ARROYO DEL OSO NONPOTABLE WATER PUMP STATION Re:

Re: ADO NPSWRP Pump Station and Reservoirs Grading and Drainage Plan

Re: ADO NPSWRP Pump Station and Reservoirs Add'l Drainage Calculations Engineer's Stamp not provided (F19/D37)

ADO NPSWRP Pump Station and Reservoirs Drainage Report Re: Engineer's Stamp dated 5-13-02 (F19/D37)

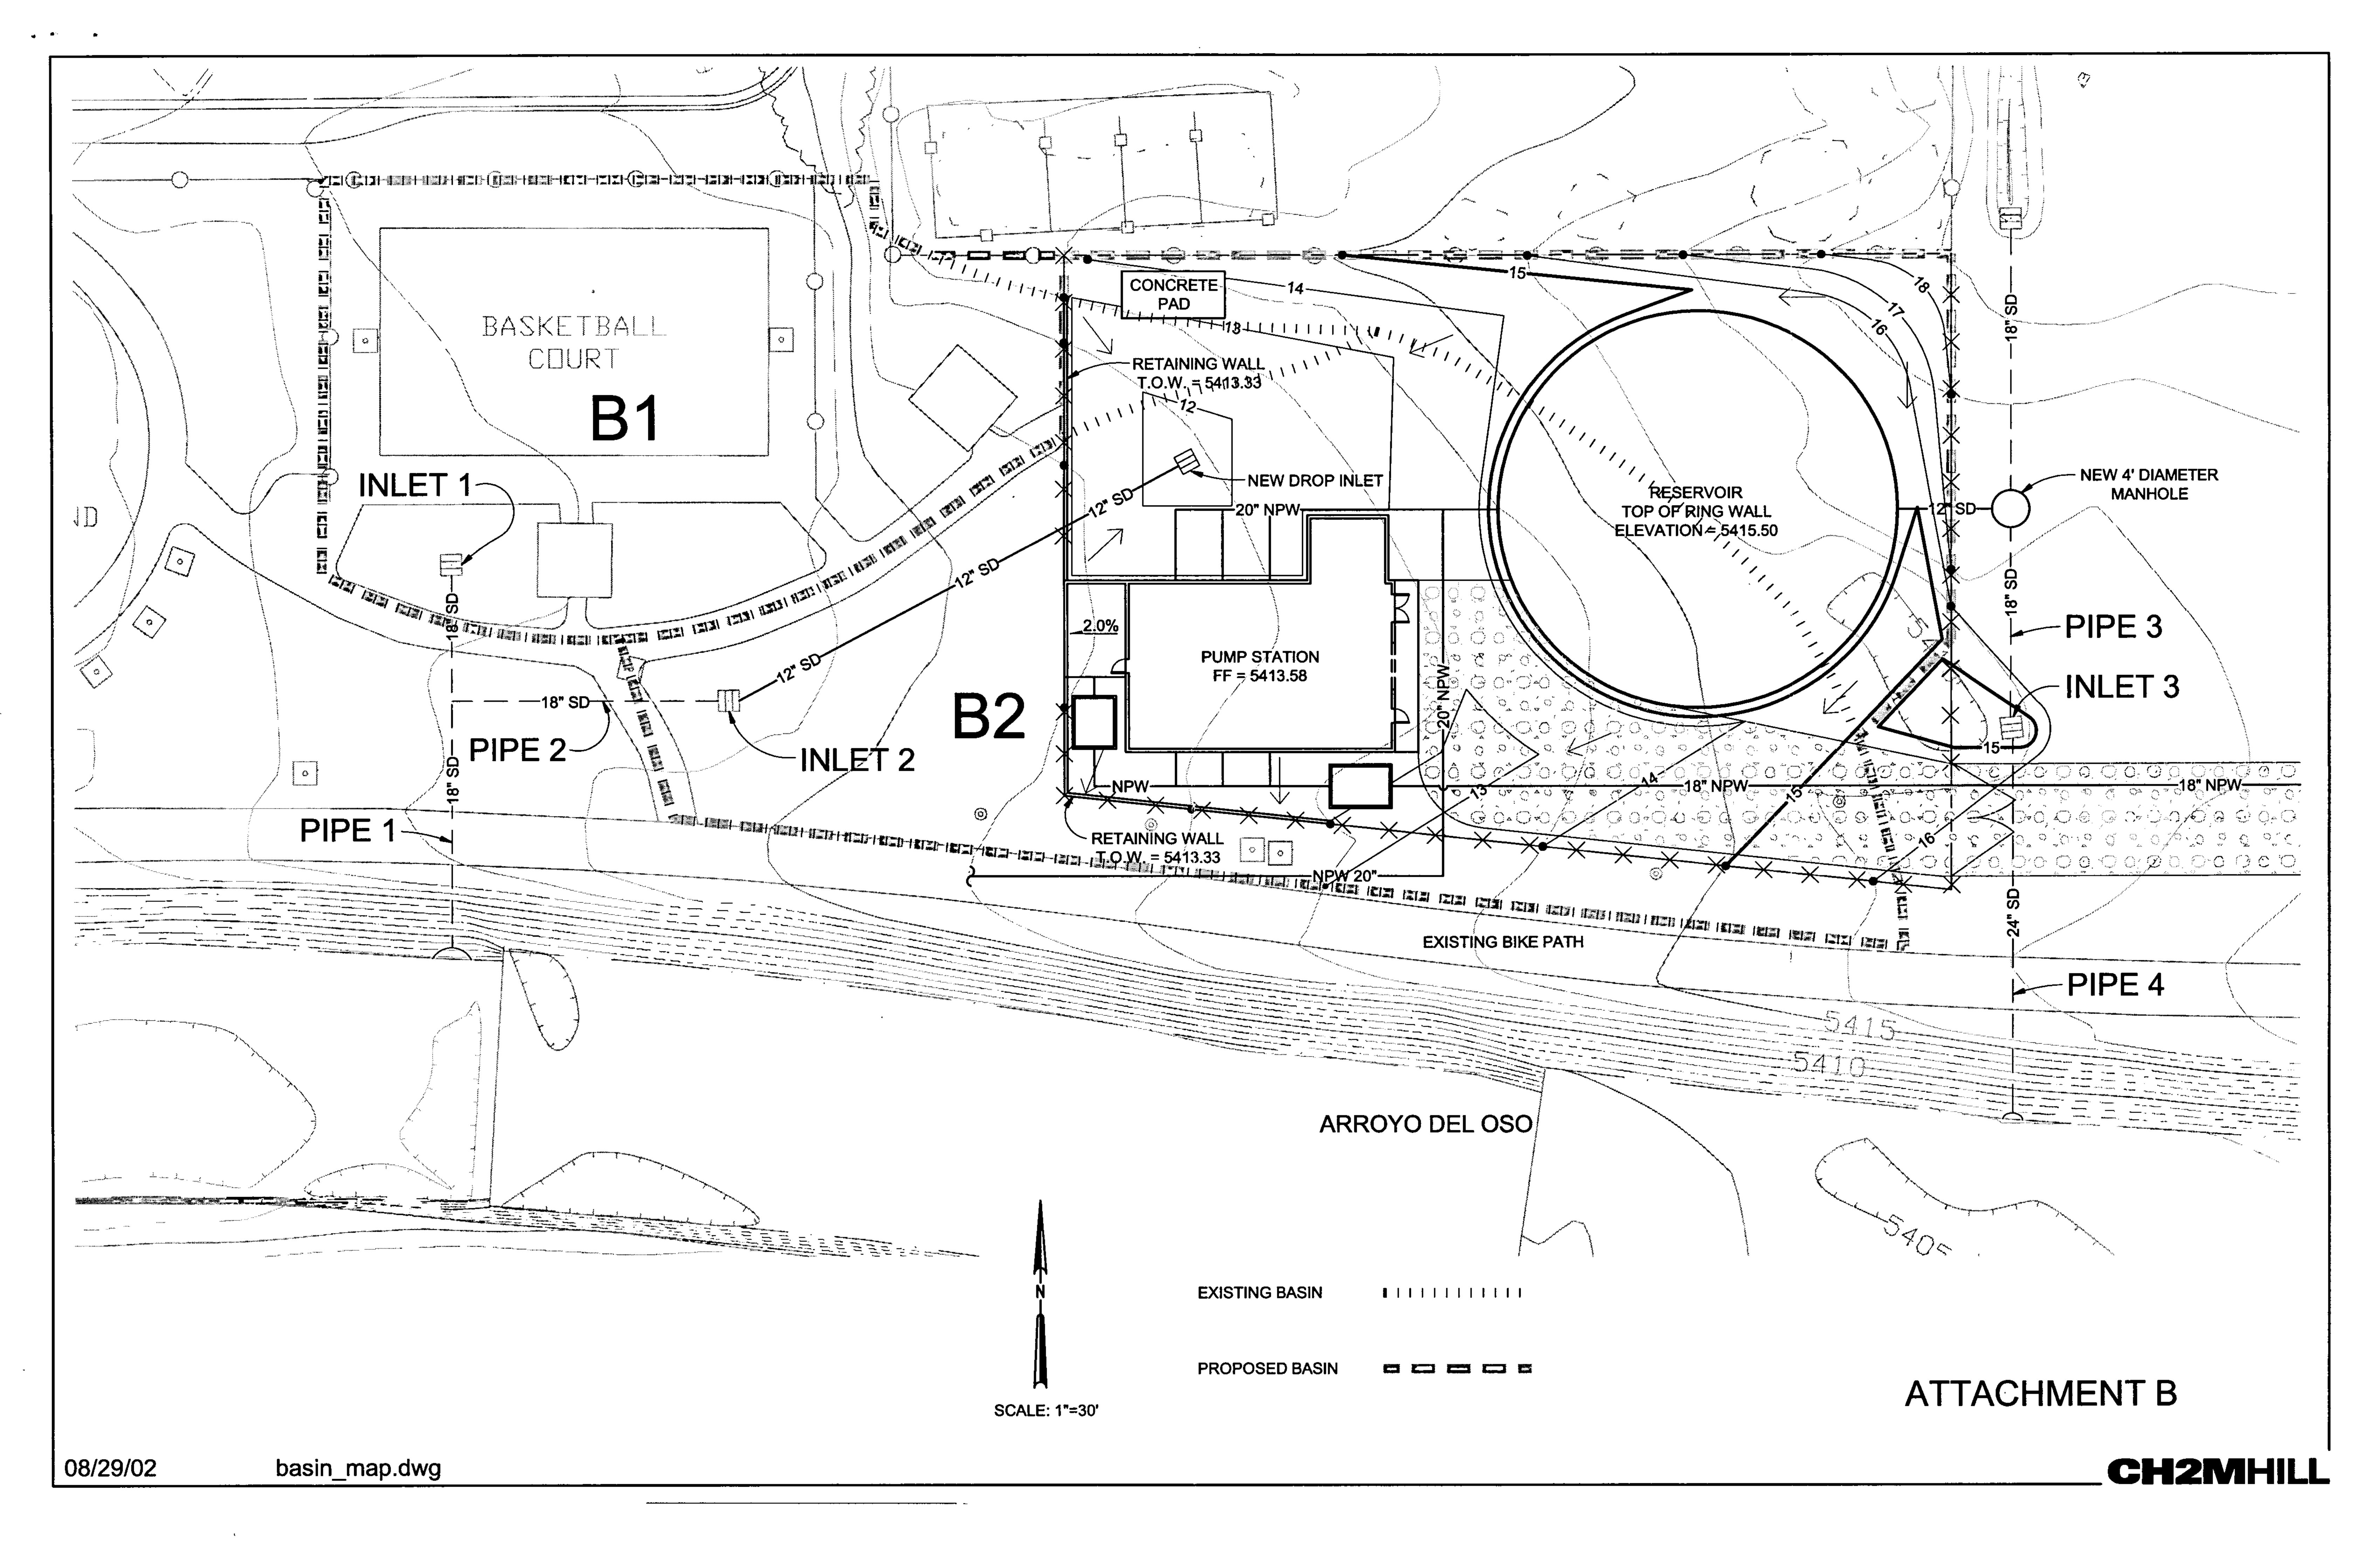
In response to your letter written May 30, 2002 Re: ADO NPSWRP Pump Station and Reservoirs Drainage Report Engineer's Stamp dated 5-13-02 (F19/D37), you approved the report for Site Plan for building Permit for action by the DRB. Approval for Work Order or Building Permit is contingent on addressing the following two items:

- The design of the gravel road will include some slope modifications near Wyoming.
   Please show all necessary regrading.
- 2. Since you are connecting to existing inlets and storm drain, verification of extra capacity will be needed to those systems. Provide all calculations, inverts and basin maps as needed to support this project. Will the existing inlet grate east of the reservoir be lowered due to your design?

An analysis of the existing storm drain system, in the vicinity of the proposed development, indicates that existing storm drain network has enough capacity to handle the additional flow from the proposed development. Each pipe segment associated with the storm drain system was analyzed to determine the impacts that the proposed development would have on the system. Attachment A shows the run-off calculations for the existing and developed basins. Attachment B shows the Basin information for the existing and developed conditions, pipe locations, and inlet locations. Attachment C and D are as-built drawings of the Arroyo Del Oso Park showing the existing drainage basins, storm drain pipe inverts, and inlet elevations used for the calculations.

Based on an analysis of the existing storm drain system with the pipes flowing full:

- Pipe 1 has an extra capacity of 18.14 cfs after developed conditions.
- Pipe 2 has an extra capacity of 17.67 cfs after developed conditions.
- Pipe 3 has an extra capacity of 0.57 cfs after developed conditions.
- Pipe 4 has an extra capacity of 18.21 cfs after developed conditions.

The flowing full capacity of Pipe 3 and Pipe 4 were calculated assuming the worst case scenario of a 100-Year 6-Hour storm event and the reservoir overflowing at the maximum pump capacity from the downstream pump station. This situation would be highly unlikely but in the event that it would occur the existing storm drain system would be able to convey the total flow.

The existing inlet grate, east of the reservoir, will not be lowered due to the new design.
